**TECHNICAL MEMORANDUM**  
**606 WEST 57TH STREET**  
**CEQR No. 13DCP080M**  
**ULURP Nos. C130336ZMM, N130337ZRM, C130339ZSM, N130340ZAM**  
**May 1, 2014**

**B. DESCRIPTION OF PROPOSED MODIFIED ACTIONS**

**606 WEST 57TH STREET  
PARKING GARAGE**

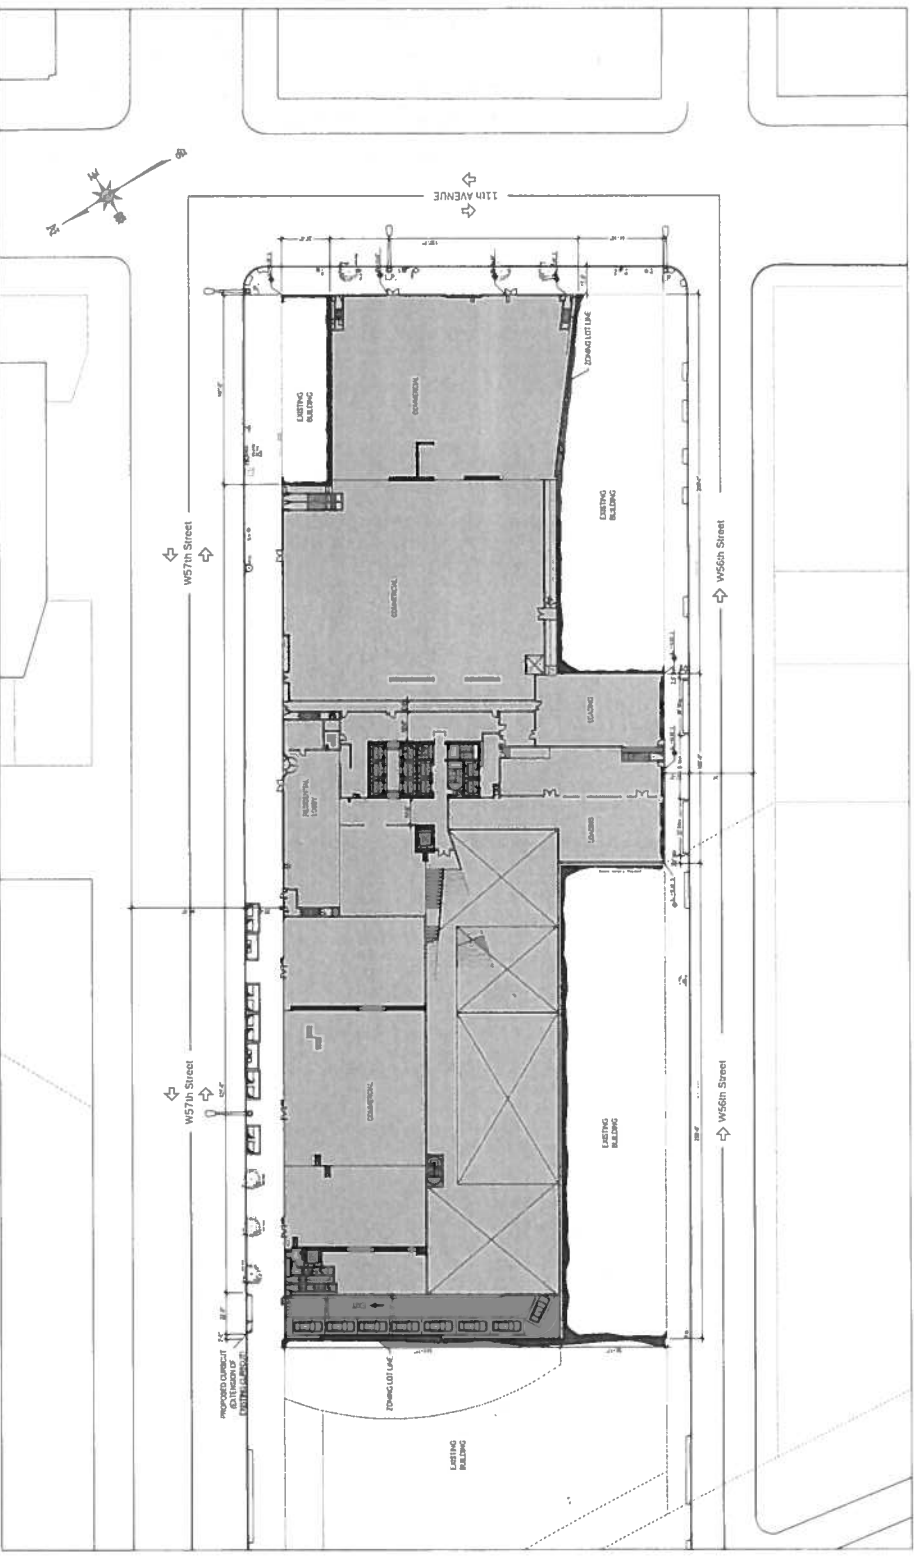
In addition, the City Council is considering a reduction, from 500 to 400, in the maximum number of spaces in the proposed garage that is subject to the special permit action under ULURP number C130339.

Thus, the FEIS already considered the potential for a smaller parking garage of 395 spaces on the project site, which is substantially the same as the 400-space maximum now being considered by the City Council as a modification of the 500-space garage scenario. In either case, there would be a parking shortfall, but it would not be considered a significant adverse impact based on the standards of the *CEQR Technical Manual*. As noted above, both the 400-space and 500-space garage alternatives utilize a ramp leading to a curb cut on West 57th Street, and the reduction of the maximum number of spaces would not affect the design or operations of the garage (see the attached plans). Therefore, this change would not result in any new or different significant adverse environmental impacts not already identified in the FEIS.

SPECIAL PERMIT REQUESTED, PURSUANT TO SECTIONS 13-45 OF THE ZONING RESOLUTION (Z.R.), FOR A PARKING GARAGE OF 400 SPACES ON PORTIONS OF THE GROUND LEVEL, & TWO CELLAR LEVELS (P1, & P2).
